Work Order ID 105911

Item ID: D212-664-101 Accept *N900040100* Setup Start *NS1*
 Revision ID: Stop *NS2*
 Item Name: Fwd Crosstube - High
 Start Date: 8/26/13 Start Qty: 1.00 *1* Cust Item ID:
 Required Date: 9/09/13 Req'd Qty: 1.00 *1* Customer:
 Reference:

DRAWING NO. D212-664-141	TITLE XTUBE ASSY (205/212/412 HI FWD)	REV. D	DART AEROSPACE LTD ENGINEERING ORDER		D.E.O. NO. D212-664-141-D-1	SHEET NO. SHEET 1 OF 2	SCALE NTS
DRAWN	CHECKED	MP	MFG. APPR.	APPROVED	DE APPR.		
DATE 11.04.07	DATE 11.07.11		DATE 11.04.12	DATE 11/09/12	DATE 11.04.12

DRAWING NO. D212-664-141	TITLE XTUBE ASSY (205/212/412 HI FWD)	REV. D	DART AEROSPACE LTD ENGINEERING ORDER	D.E.O. NO. D212-664-141-D-1	SHEET NO. SHEET 2 OF 2	SCALE NTS
DRAWN	CHECKED	CP	MFG. APPR.	CE	APPROVED	DE APPR.
DATE 11.04.07	DATE 11.04.11	DATE 11.04.12	DATE 11/04/12	DATE 11.04.12	DATE 11.04.12

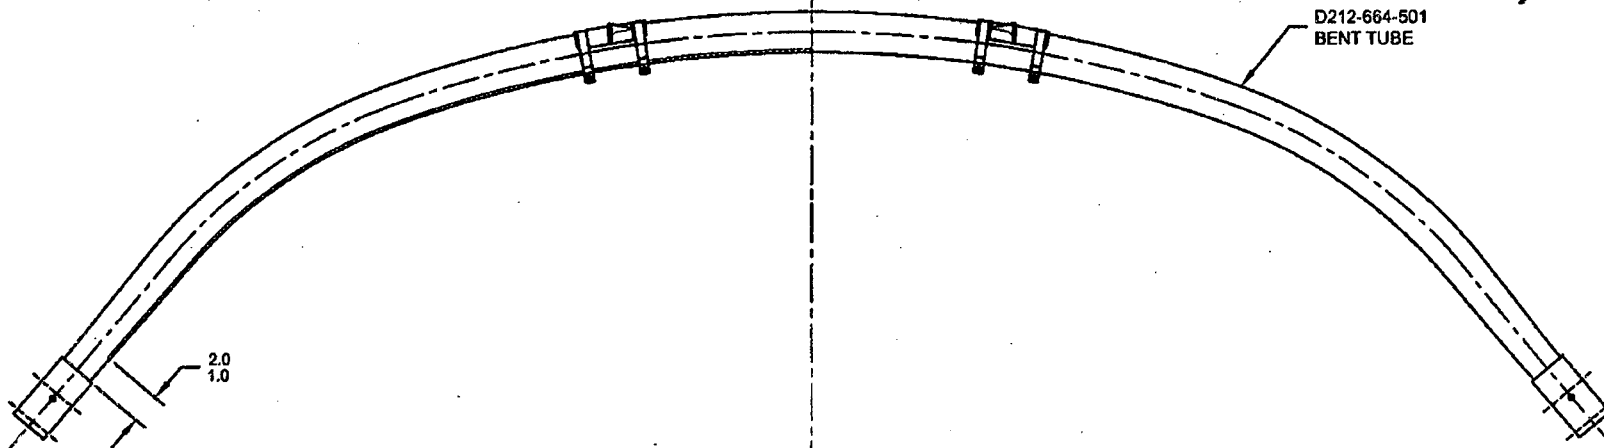
ADD AN INSPECTION WINDOW TO UNDERSIDE OF CROSSTUBE.

NOTES 2 OF SHEET 1 IS AMENDED AS FOLLOWS:

- 2) FINISH: CHEMICAL CONVERSION COAT PER DART QSI 005 4.1
PRIME INSIDE AND OUTSIDE PER DART QSI 005 4.2
MASK UNDERSIDE OF CROSSTUBE AS SHOWN (HATCHED AREA) AND
PAINT OUTSIDE PER DART QSI 005 4.2
REMOVE MASKING AND APPLY CLEAR COAT

MASK AREA PRIOR TO PAINTING,
REMOVE MASKING AFTER PAINT
AND APPLY CLEAR COAT
